PCN (Product Change Notice)

PCN Number: PCN_UtWPCC-Rx_20250904

Affected Series: WE-WPCC

Affected Part Number: 760308101309

Before Change	After Change

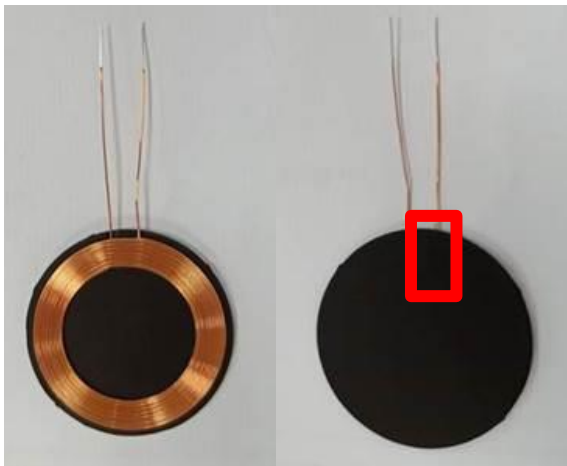
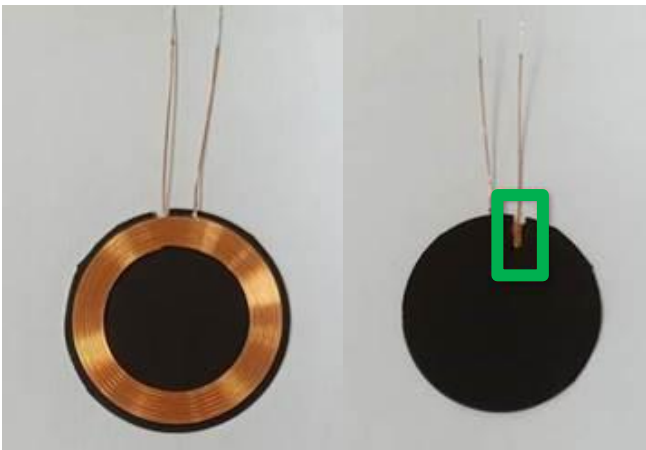
To improve the processability, Würth Elektronik will be removing the PET film underneath the lead out of the coil. There will be no change in fit, function, quality or reliability of the product.
